UNITED STATES PATENT AND TRADEMARK OFFICE

Office Action Summary	Application No. 10/628,063	Applicant(s) LAWSON, DOUGLAS K.	
	Examiner Erica E Cadugan	Art Unit 3722

DETAILED ACTION

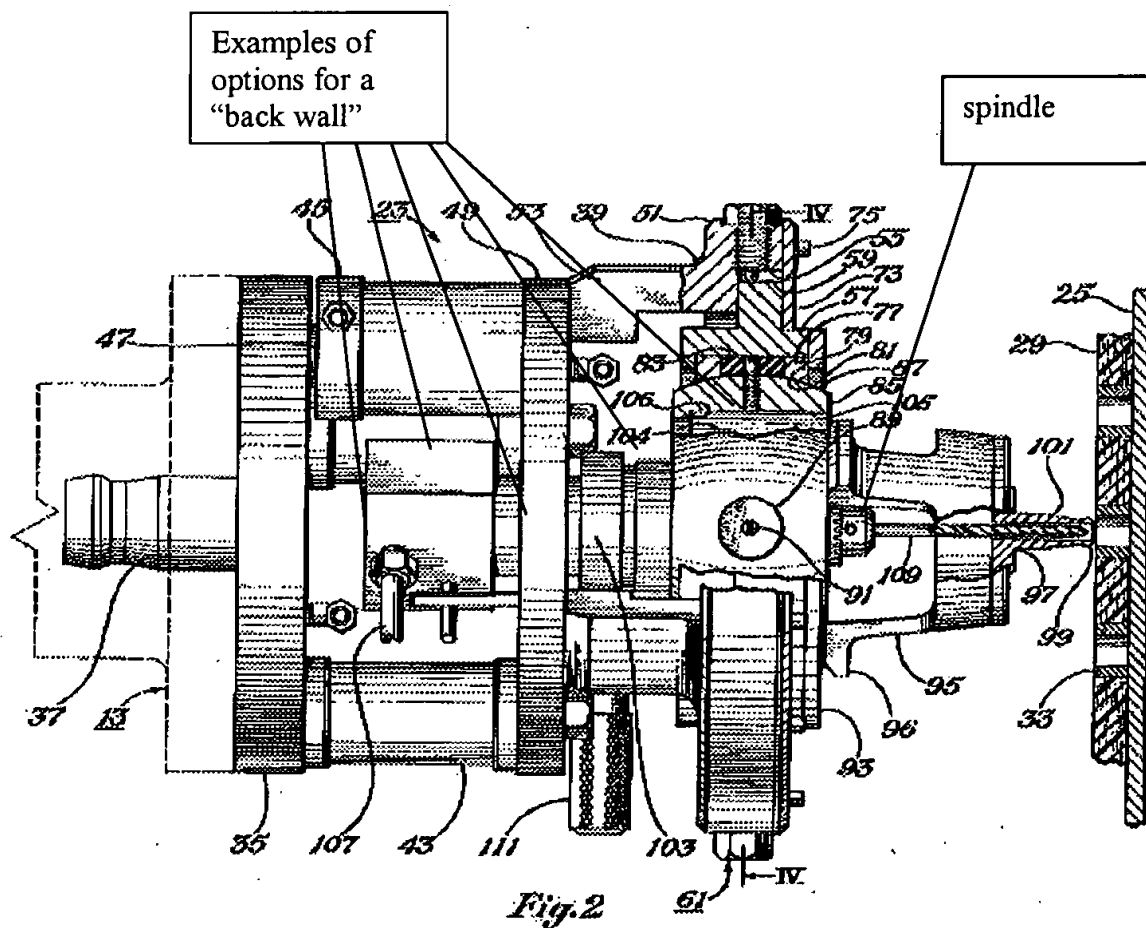
Hailey teaches a robotic drilling device. It is noted that there is nothing preventing an end user from using a drill to “deburr” a hole, for example. Hailey’s device includes a drill 103 having a drill motor that is “driven by air supplied to a manifold through conduits 107” (col. 4, lines 26-27. Note that the motor is located within a “housing”, such as being located at least within the perimeter of members 51 and 53, see Figure 2.

Also, as illustrated in the above reproduction of Figure 2, there are several walls or surfaces of Hailey’s device that can be considered a “back wall”, forming a “back portion” of the device or motor as set forth in claim 14, for example, particularly since they are walls or portions that are located “away” from the vicinity of the “front” portion where the cutter is located.

At the right (as viewed in Figure 2) end of the drill 103 is mounted a cutter 109, and thus the right end of the drill (as shown above) can be considered a spindle, and the vicinity in which the cutter 109 is attached to the spindle is considered the “front” end of the device as claimed.

Note also that ring 79 has a concave spherical (see Figures 2 and 4, also col. 3, lines 33-66, and especially col. 3, lines 59-63, for example) surface 81, constituting a bearing surface, and thus ring 79 constitutes the claimed “pivot bearing”. Spherical member 85 has a convex surface that mates in sliding contact with the surface 81 (see Figures 2, 4, and col. 3, lines 33-66, for example). Note that member or “pivot bearing” 79 is located “adjacent” various ones of the aforescribed “back walls” and is thus considered “adjacent” to the “back portion” of the motor. Also note that member 85 extends “from” a circumferential wall that can be considered a “back wall” or a part of a “back portion” as described previously, and thus member 85 constitutes the claimed “connector”.

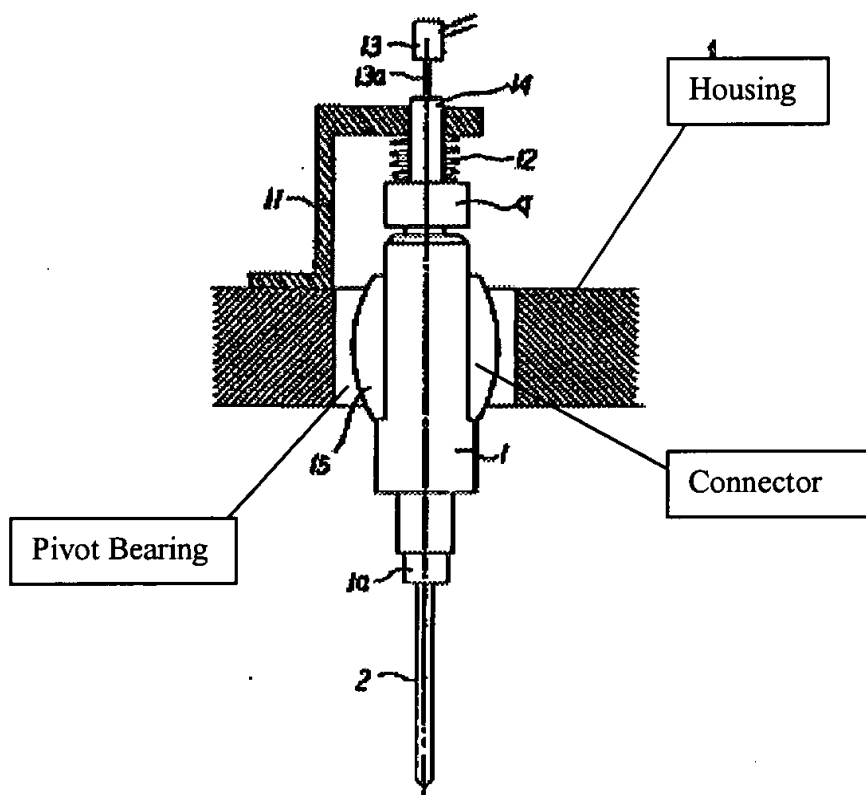
Note that '811 teaches a deburring device (see English abstract) having a motor 1 (Examiner orally consulted a Japanese translator who indicated that the first full paragraph in the upper left portion of the left column on page 70 teaches that element 1 is a motor whose driving source is either electric or fluid) mounted within a housing (as indicated in the reproduction of Figure 5 below).

Note that the “pivot bearing” (shown above) is located “adjacent” the “back portion” of the motor, as broadly claimed. Further note that ‘811 teaches the connector extending between the motor 1 and the pivot bearing as shown above.

Regarding claim 15, note, for example, that the outer circumferential wall of the motor where the pivot bearing and connector 15 are located can be considered the “back wall” as claimed, since, for example, that is a wall that is located at the “back” of the motor with respect to where the tool 2 is located. Also note that the “pivot bearing” has an opening in which the “connector” is located (see Figure 5).
